# PEUGEOT / CITROËN THERMOSTAT REDESIGN TO OVERCOME OVERHEATING

Issue Date: 22/06/18 Issue Number: COTB0021F

**APPLICATION :** Citroën C3 II, C3 Picasso, Peugeot 2008, 207, 208, 508, Partner Box

**APPLICABLE REFERENCES :** FTK422 / FTK454

OLD DESIGN	NEW DESIGN
 <p>4 Pin Plug</p> <p>FTK422</p>	 <p>Electronically Controlled Thermostat</p> <p>2 Pin Plug</p> <p>2 Pin Plug</p> <p>FTK454</p>

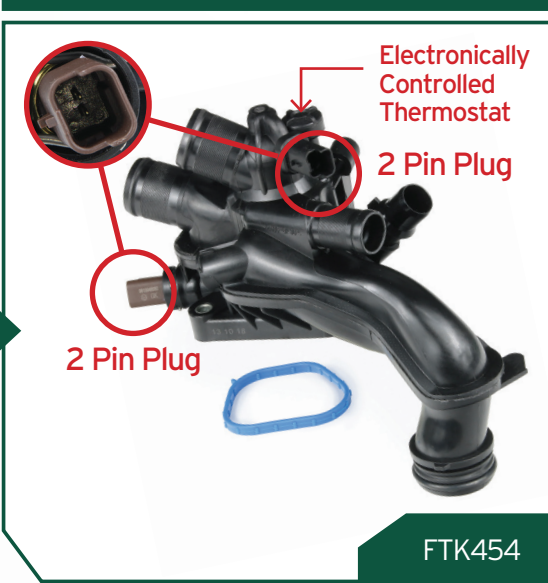
Due to an increase in overheating issues & symptoms such as an erratic temperature gauge, erratic running, radiator fan run-on, or poor heater function in the above vehicles, the O.E.M. have modified the design of the Thermostat housing. Following the O.E. specification, we have replaced the old design FTK422 with the new latest design FTK454. The latest design benefits from an electronically controlled thermostat, a reinforced structure, and a new configuration of sensors.

We have highlighted the key differences below so that you are clear that the latest part, although visually different to what may be on the vehicle, is in fact the correct product.

The modified version has two 2 Pin connectors instead of the one original 4 Pin connector, therefore a new cable is also required to carry out the modification.

If your vehicle has the FTK422 or equivalent, then it is recommended that this is replaced with the updated version FTK454. It is advised that following replacement of these components, the software is checked and re-programmed / flashed to ensure that it is operating with the latest version.

New Cable: FTS3091 - Thermostat Wiring Harness
